MONITORING YEAR 6 ANNUAL REPORT

HOGAN CREEK STREAM MITIGATION PROJECT

RE: Hogan Creek Stream Mitigation Project
Yadkin River Basin – CU# 03040101
Surry County, North Carolina
NCEEP Project # 94708
Contract No. 6496

Wildlands Engineering, Inc. (Wildlands) has reviewed the Division of Mitigation Services (DMS) comments from the Draft Monitoring Year 6 report for the Hogan Creek Stream Mitigation Project. The following Wildlands responses to DMS's report comments are noted in italics lettering.

Figure 3.1 Current Condition Plan View Map (Sheet 1 of 3)
 Hogan Creek Stream Mitigation Project
 DMS Project No. 94708
 Monitoring Year 6 - 2020

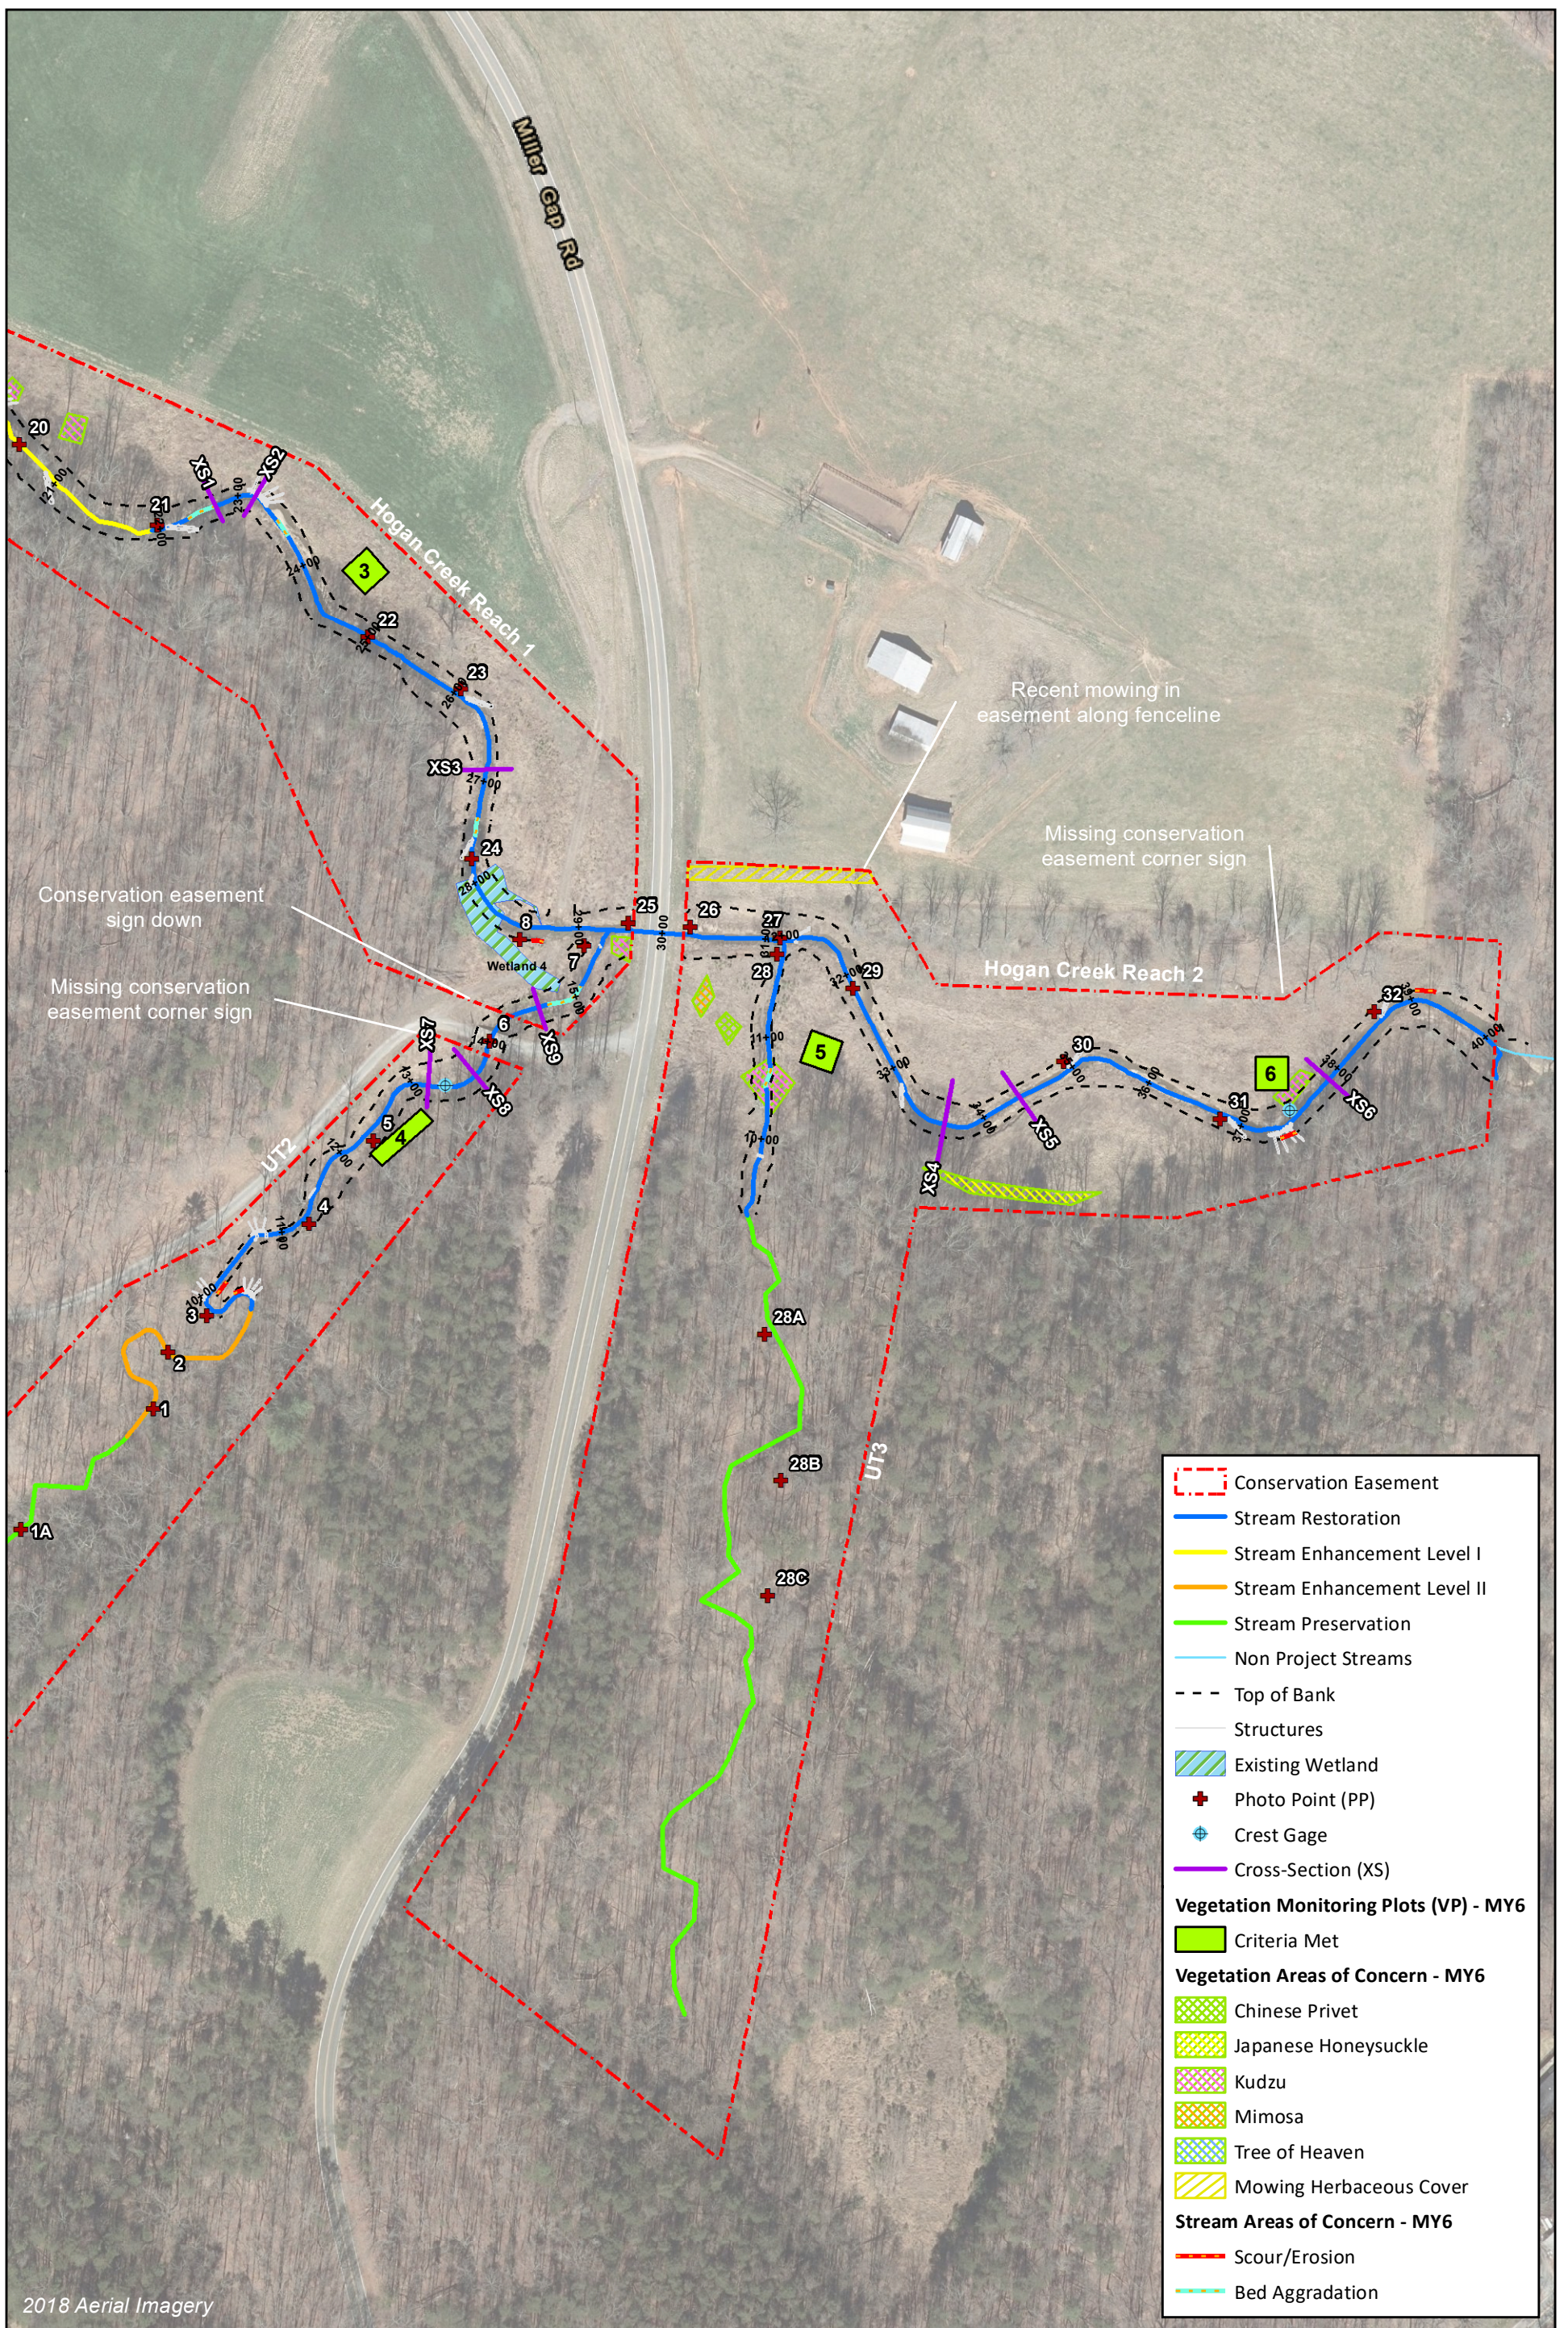
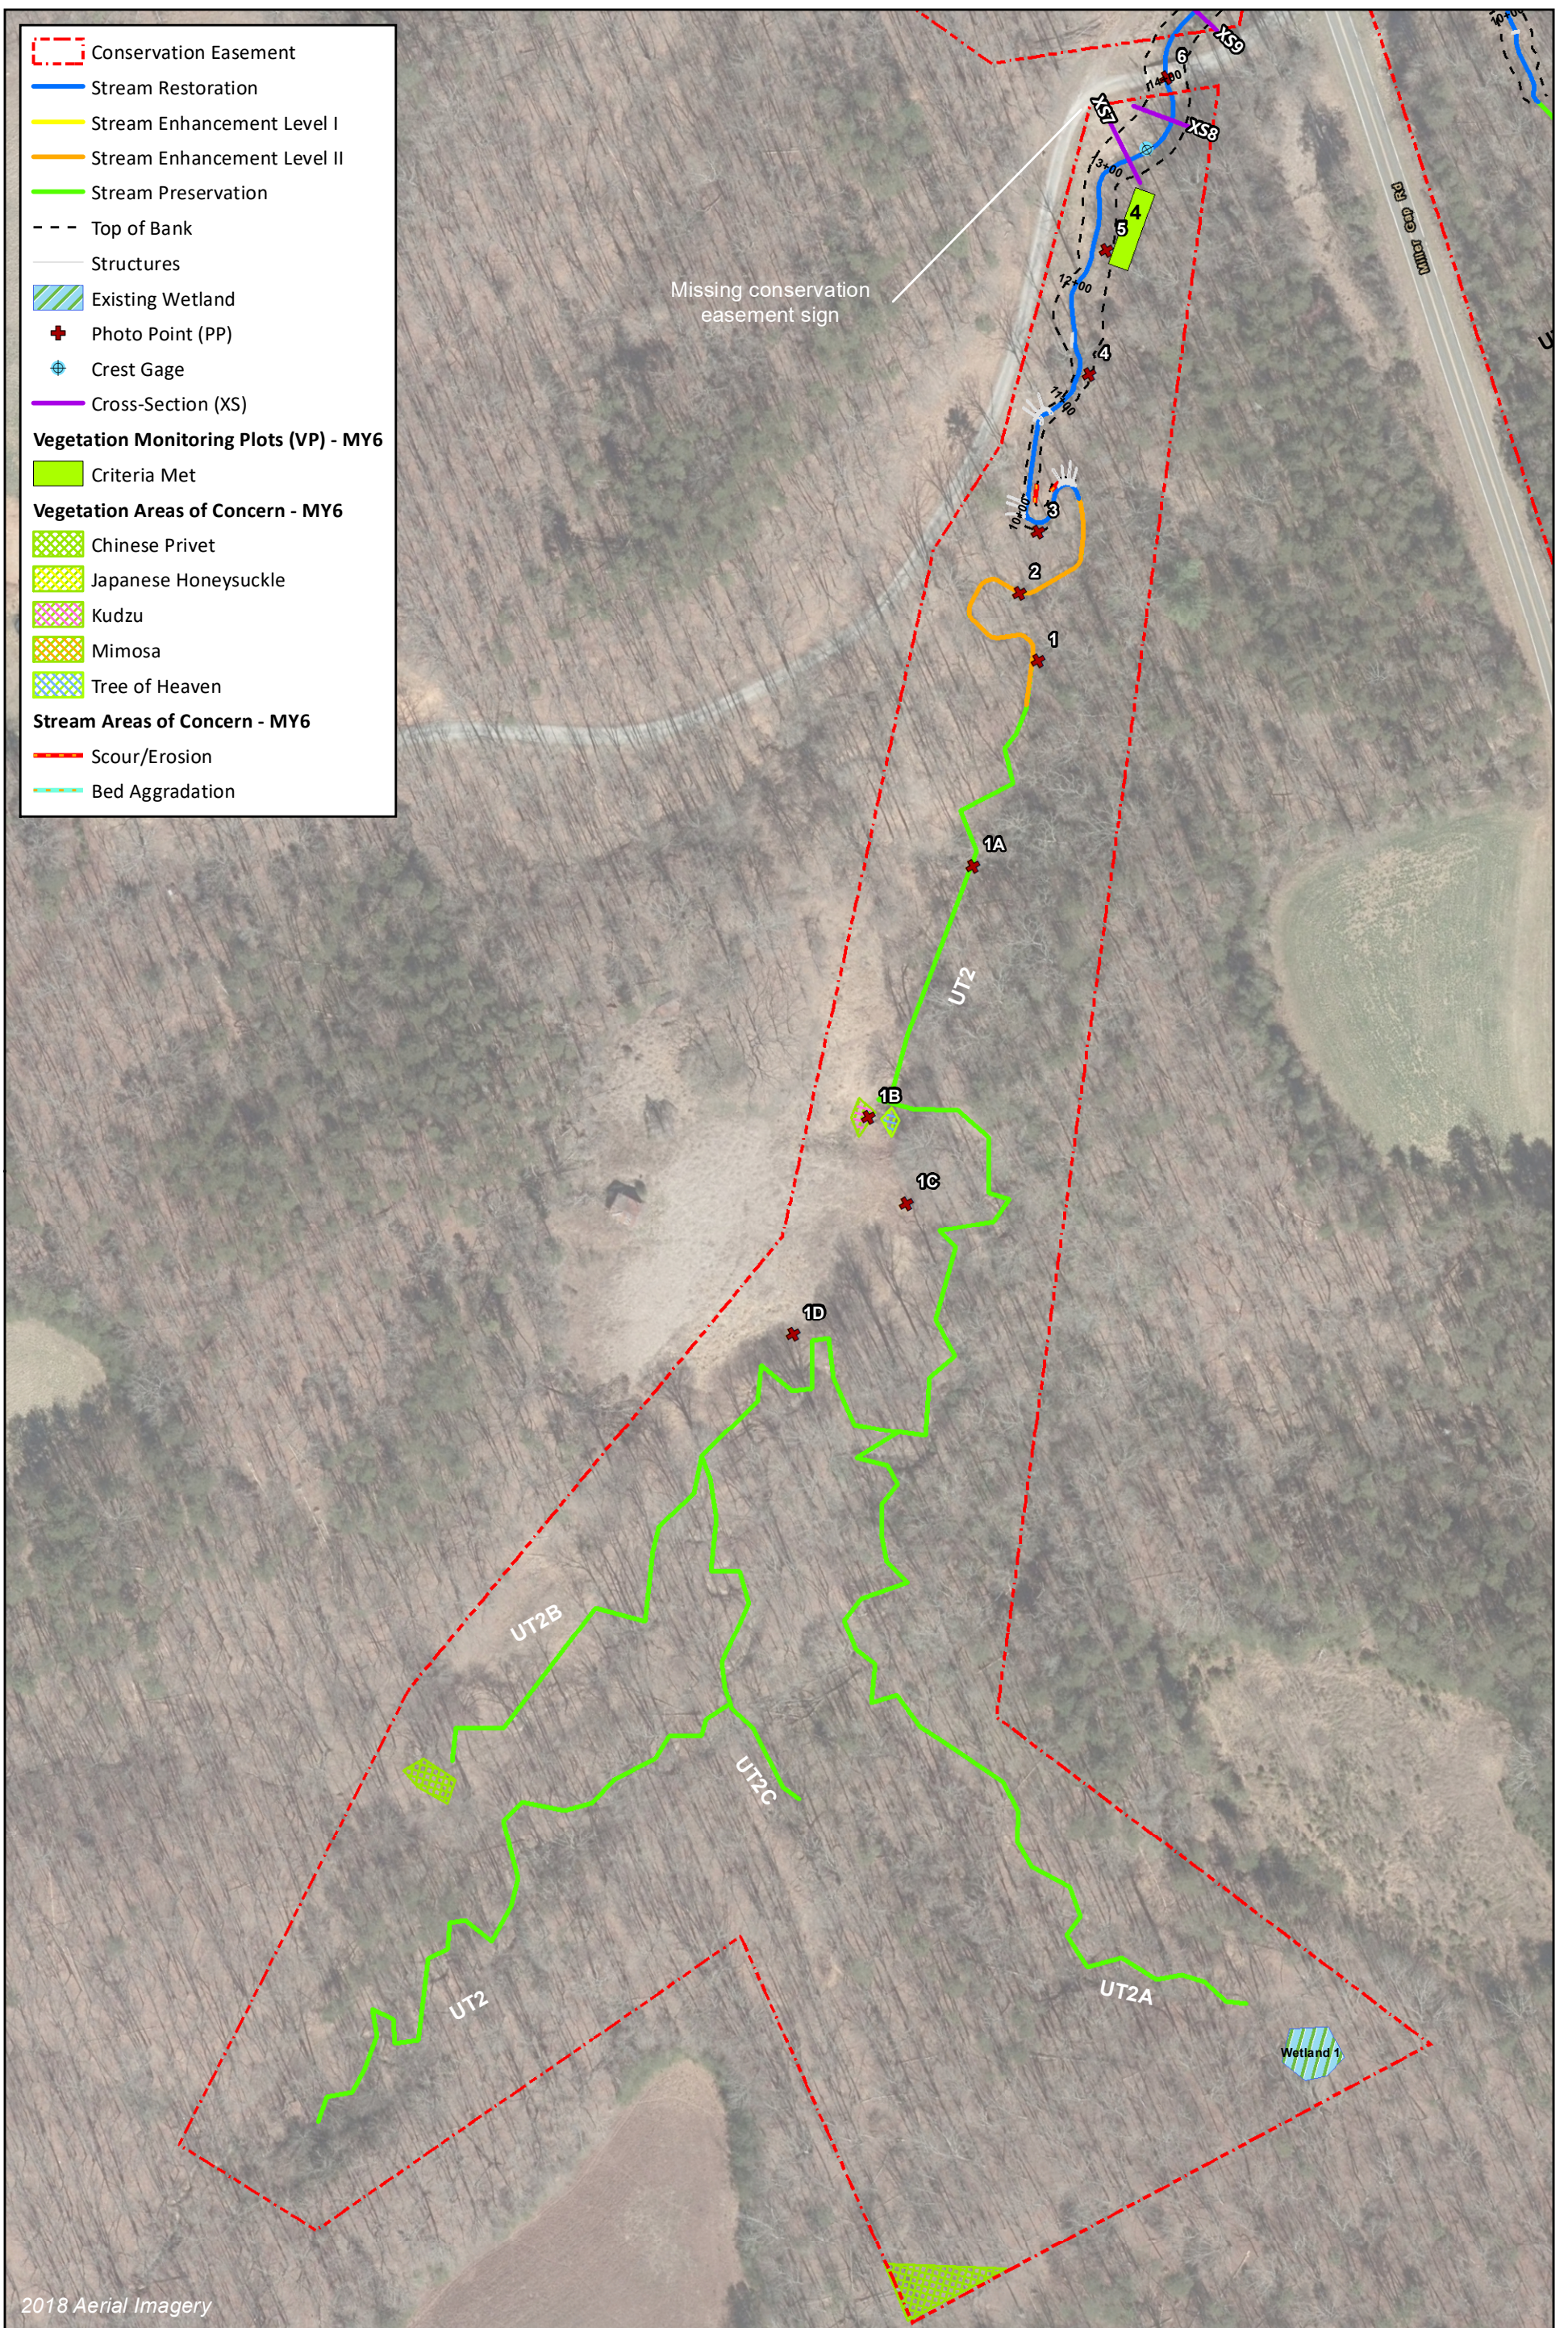
DMS comment; Thank you for updating the CCPV to reflect the invasive treatment that has occurred on the site. DMS will continue to have the invasives treated through December 2021.

Wildlands response; Text in Section 1.2.2 has been updated to specify that invasive treatments will continue through December 2021.

DMS comment; Table 6b and 6c: There are two structures marked as unstable under the “Overall Integrity” category, but they are not shown on the CCPV or discussed in the stream problem area of the report. Can you please verify if these are still problems or if they have healed over time? Please add a call out or mark the location of the structures on the CCPV if they are a problem or remove from the table.

Wildlands response; Two rootwad structures, one along Hogan Creek Reach 2 near station 37+30 and the other along UT2 near station 9+50, were noted to have some bank scour at these locations which is shown on the CCPV. However, upon additional consideration, the overall integrity of these structures has not been compromised since the bank scour is minor with woody vegetation still established along the bank. Tables 6b and 6c have been updated to account for this just in the Bank Protection channel sub-category.
